Project: Police Memorial and North Cove
Marina Electrical Vault Resilience
Project Construction Services
(November 2015)

RE: Addendum # 2
of Pages: (7 pages)

The following revisions and/or clarifications are to be made to the Request for Proposals for “**Police Memorial and North Cove Marina Electrical Vault Resilience Project Construction Services**” in response to questions submitted by prospective proposers.

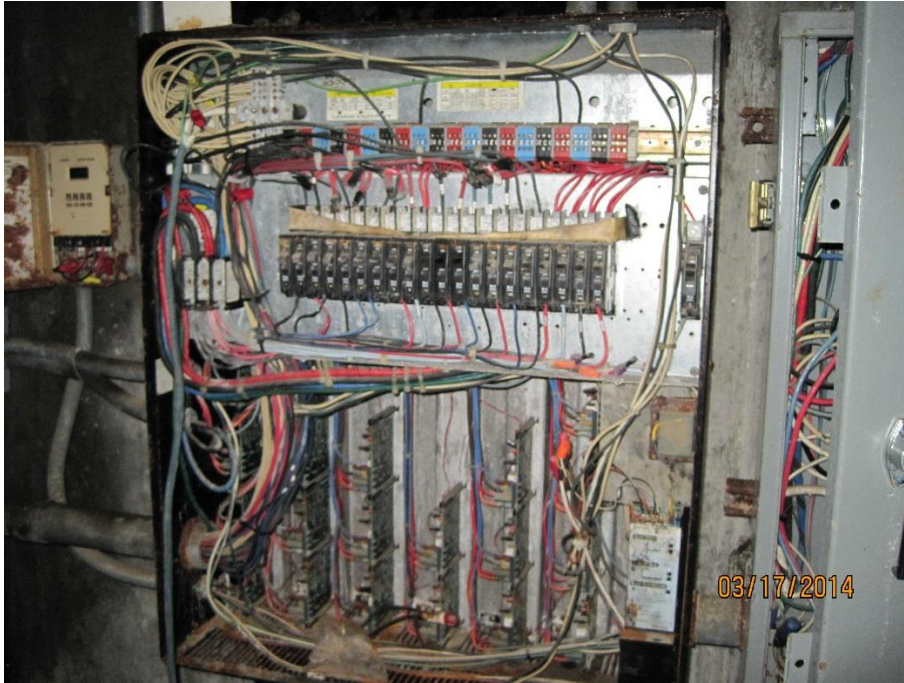
7. With reference to drawing E400 detail 1, please provide contact information for existing lighting Control system Manufacturer.

The existing lighting control system is a Lutron system which was completely destroyed by Superstorm Sandy. See photo below. Contact telephone number for Lutron is [800-523-9466](tel:800-523-9466).
